UNITED STATES PATENT AND TRADEMARK OFFICE

APPLICATION NO.	FILING DATE	FIRST NAMED INVENTOR	ATTORNEY DOCKET NO.	CONFIRMATION NO.
09/964,639	09/28/2001	Dong-Gyu Kim	6192.0186.AA	1991

Office Action Summary

DETAILED ACTION

FIG. 7

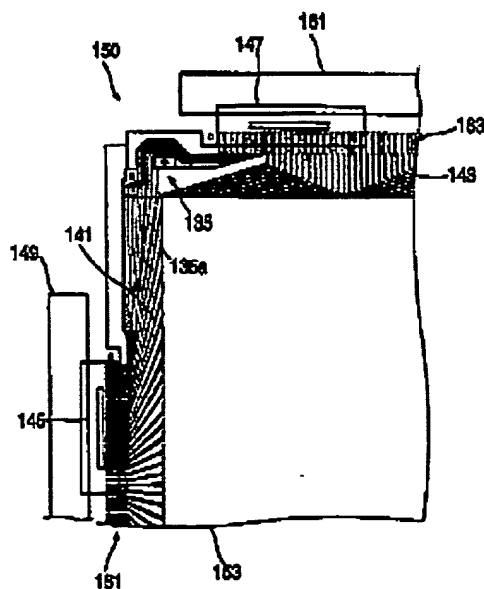
11. Park discloses and shows in Figs. 7 and 8, a display device, comprising:

- a first substrate having a plurality of gate lines (141) and a plurality of data lines (143);

- a plurality of thin film transistors (T) electrically connected to the gate lines (141) and the data lines (143);
- a plurality of pixel electrodes electrically connected to the thin film transistors respectively (page 1, paragraph 0006);
- a plurality of gate driving ICs (145) to output gate signals to the gate lines (141) (page 3, paragraph 0035);
- a plurality of source driving ICs (147) (applicant's data driving ICs) to output data signals to the data lines (143) (page 3, paragraph 0035); and
- a plurality of gate transmitting lines (135) (applicant's interconnection lines) apply gate control signals to at least one of the gate driving ICs (145) (page 3, paragraph 0035).

Park differs from the instant invention because he does not explicitly disclose the claimed black matrix overlapping at least one of the interconnection lines.

As to claim 39, Park also discloses and shows in Fig. 7 that the device further comprising a gate PCB (149) and a source PCB (151) (applicant's driving signal transmission film) wherein at least one of the data driving ICs (147) is mounted on the driving signal transmission film (151) (pages 3-4, paragraph 0054).

As to claim 40, it is clear from Fig. 7 of Park that the driving signal transmission film (149 and 151) outputs the gate control signals and the data signals to the interconnection lines and the data lines respectively.
